802.3dj D3.1

Comment Resolution

Optical Topics

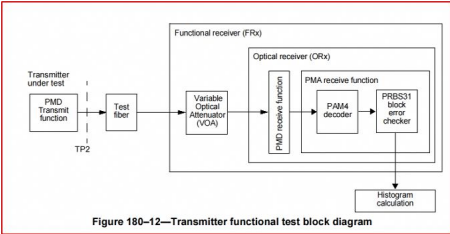
This says "the best estimate of the actual MPI and DGD penalties of the test fiber", yet the fibre alone doesn't make much MPI. The reflections between transmitter and connectors, and receiver and connectors, are more important. It is not clear which reflections are taken as baseline and which are attributed to the fibre, particularly as both transmitter and receiver reflectances are not necessarily at the spec limits. MPI varies with polarisation yet there is no polarisation control in Figure 180-12.

If the TFT section is kept;
if MPI penalty variations are important, explain how the MPI penalty is to be estimated and add polarisation control. If MPI penalty variations are not so important or not feasible to estimate with confidence, use a fixed allocation

Comment R1-283

TFT test fiber correction

The transmitter under test is connected to the FRx by a test fiber which meets the requirements in 180.9.6.2. Full compliance with 180.9.6.2 requires the test fiber to provide back reflection with polarization state resulting in the greatest RIN. Other test fibers, including patch cords, may be used for additional tests.

“the power budget of the test fiber using the best estimates of the test fiber channel insertion loss, MPI and DGD penalties, and TDECQ of the DUT over the test fiber and is given by Equation (180-20)”

→ Allowing users to set MPI_DGD_Penalty to 0, or other value based on test setup conditions.

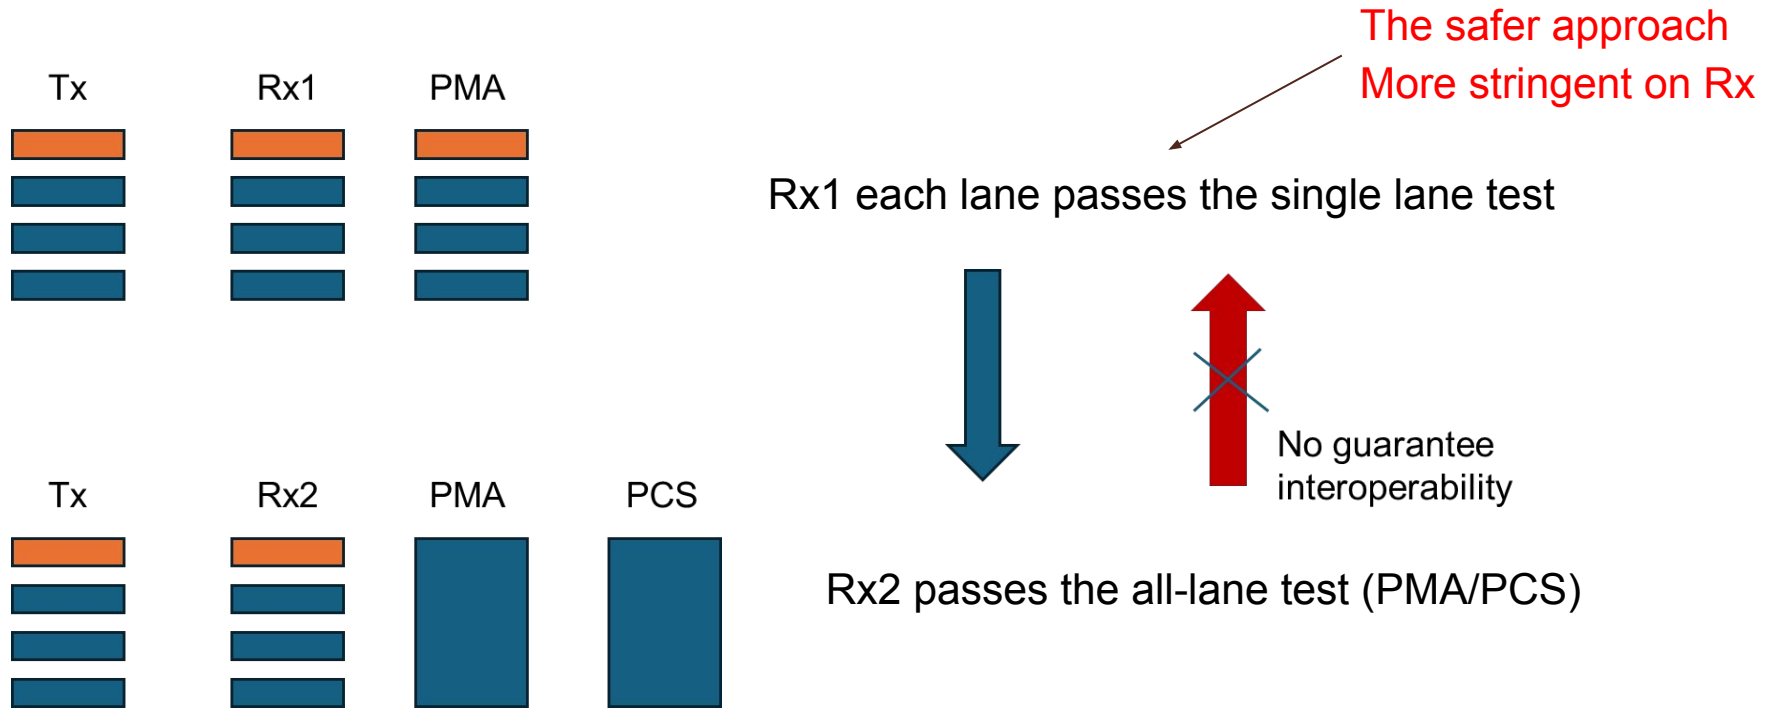
This comment is in support of comment i-493 against D3.0. For a multilane system what matters is the Frame Loss Ratio of the interface which is a function of the performance of all the lanes. It is not necessary for all the lanes to meet the specification here. Also it is not possible to test the performance of the individual lanes when using scrambled idle (pattern 5). Also the test method called out in 174A.9.6 (allowed by page 492 line 2) specifically allows is a multilane test.

Delete "of each lane" here and for stressed sensitivity on page 493 line 37. Make the equivalent changes in clauses 181, 182, and 183 (note that the change is not needed in 181.9.15 or 183.9.15 as they already do not say "of each lane". If the committee decision is that all lanes must meet the specification individually then pattern 5 needs to be removed as a test pattern option, 174A.9.6 needs to be deleted and exceptions need to be made to 174A.9.5 and 174A.9.7 which allow the use of 174A.9.6.

PROPOSED ACCEPT IN PRINCIPLE.

Removing "each lane" as an option is addressed by the reponse to comment R1-294.

Implement the following changes:

delete pattern 5 from test pattern specified for receiver sensitivity and Stressed receiver sensitivity in Table 180-13.

delete reference of 174A.9.6 from the receiver sensitivity methodology.

Delete the note that begins with "When measuring receiver sensitivity of a complete PHY at the PCS...."

Add an exception in 180.9.14 and 180.9.15 that, when testing using 174A.9.5 or 174A.9.7, the compliance may not be further verified using 174A.9.6.

BLER test method for all lanes 174A.9.6

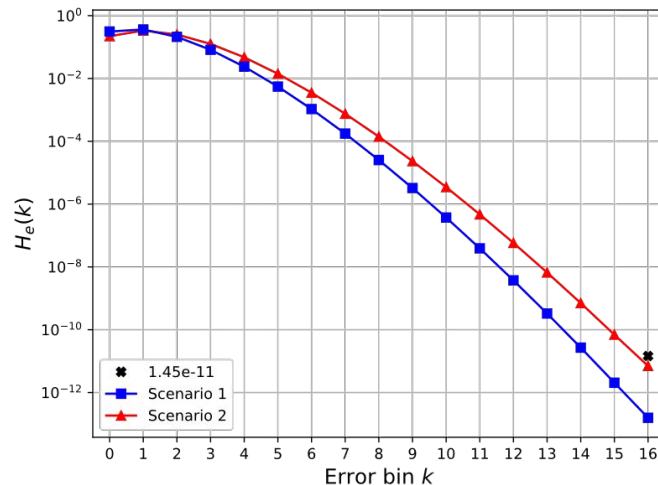
Assume four optical lanes 0,1,2,3, consider two scenarios:

1. BER over four lanes is [3e-4, 1e-4, 1e-4, 1e-4]
2. BER over four lanes is [2.5e-4, 2e-4, 2e-4, 2e-4]

Calculate $H_e(k)$ with $BER_{added} = 6.4e-5$, and compare $H_e(16)$ with $1.45e-11$

Both scenarios pass the test method for all lanes, but with $BER > 2.28e-4$ for lane 0.

Propose to use only the per-lane test method for receiver sensitivity, and define receiver sensitivity as per-lane property
